Access Compliance Report

Public Rights-of-Way

(Curb Ramps)

Intersection ID: 50729	Main Street: TODDINGTON_LN	Cross Street: ALDERGROVE_RD	Location:	N
ADA ID: ADFDEDF3BA95	Ramp Type: PerpDiag	Initial Pass/Fail: Fail	Overall Compliance: No	Severity Score: 8.75

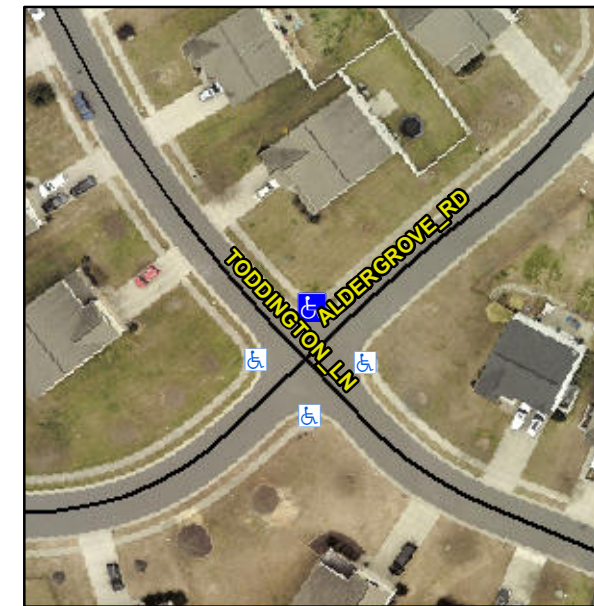
Not Found, R304.5.1

Compliance	Description	Data	Compliance	Description	Data
N/A	Ramp Length (in)	48.5	Yes	Ramp Slope (%)	7.4
No	Ramp Width (in)	47.0	Yes	Ramp XSlope (%)	1.2
N/A	Flare Type LT	N/A	N/A	Flare Type RT	N/A
N/A	Flare Slope LT (%)	N/A	N/A	Flare Slope RT (%)	N/A
N/A	Flare Traversable LT?	N/A	N/A	Flare Traversable RT?	N/A
N/A	Landing Length (in)	N/A	N/A	DWS Provided?	N/A
N/A	Landing Width (in)	N/A	N/A	DWS Contrast?	N/A
N/A	Landing Slope (%)	N/A	N/A	DWS Length (in)	N/A
N/A	Landing X Slope (%)	N/A	N/A	DWS Full Width?	N/A
N/A	Landing Curb? (Y/N)	N/A	N/A	DWS Offset (in)	N/A
N/A	Shared Landing?	N/A			
N/A	Gutter Ponding?	N/A	N/A	Gutter Slope (%)	N/A
N/A	Gutter Lip Ht (in)	N/A	N/A	Gutter X Slope (%)	N/A
N/A	Painted X Walk1?	No	N/A	Painted X Walk2?	No
	X Walk 1 Direction	To SW		X Walk 2 Direction	To SE
N/A	X Walk 1 Width (in)	N/A	N/A	X Walk 2 Width (in)	N/A
	X Walk 1 Slope (%)	1.7		X Walk 2 Slope (%)	3.3
	X Walk 1 X Slope (%)	3.3		X Walk 2 X Slope (%)	2.4

Remove & Replace Curb Ramp With Two New Directional Ramps or Equivalent.
